Tennessee Valley Authority, Watts Bar Nuclear Plant, Unit 2  
Docket No. 50-391

Subject: **Revised Response to Request for Additional Information  
Question 3 Regarding Final Safety Analysis Report Section 2.4  
(TAC NO. ME3945)**

1. Revised Response to Request for Additional Information Question 3 Regarding Final Safety Analysis Report Section 2.4
2. Revised FSAR Figure 2.4-72

**REVISED FSAR FIGURE 2.4-72**

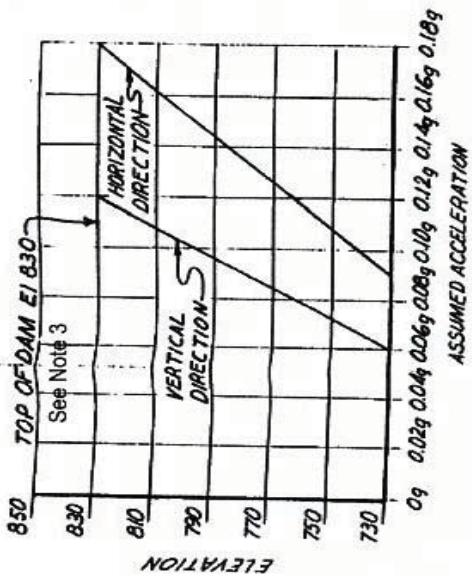
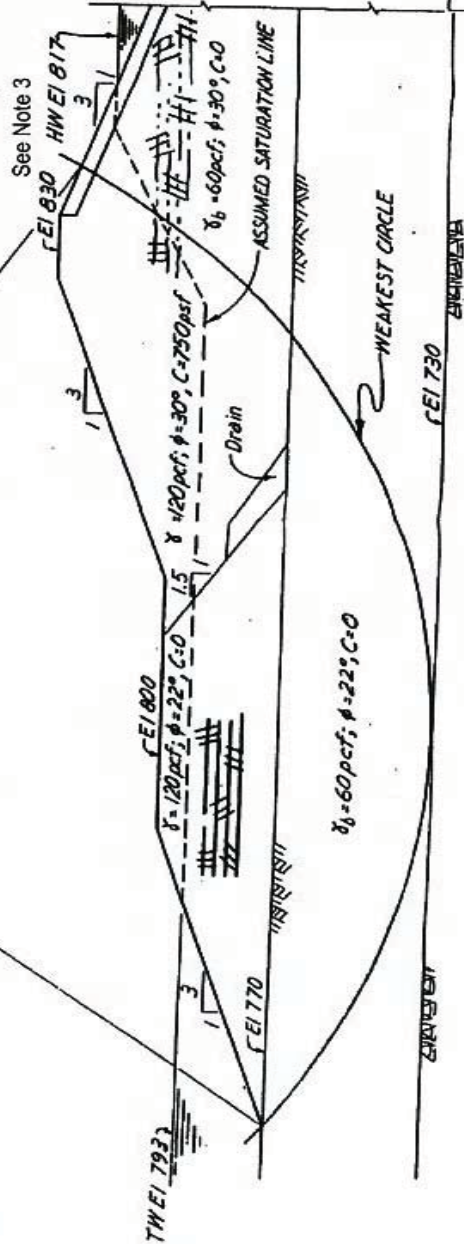
Regarding the RAI question 2 response submitted in the referenced letter, TVA agreed to revise FSAR Figure 2.4-72 to show the sand baskets. An FSAR Change Request has been submitted to include this revision in FSAR Amendment 104. A copy of the Figure submitted with the Change Request is provided in Enclosure 2. Note 3 was added to Figure 2.4-72 to describe the sand baskets.

- NOTES:
1. Analysis was made using the standard slip circle method.
  2. Shear strengths of materials same as used in original analysis.
  3. Improvements have increased the effective height of the embankment to a minimum EI 836 (See Fort Loudoun Project Drawing 10W222-1). Field surveys indicate a minimum height of EI 836.9 was achieved.
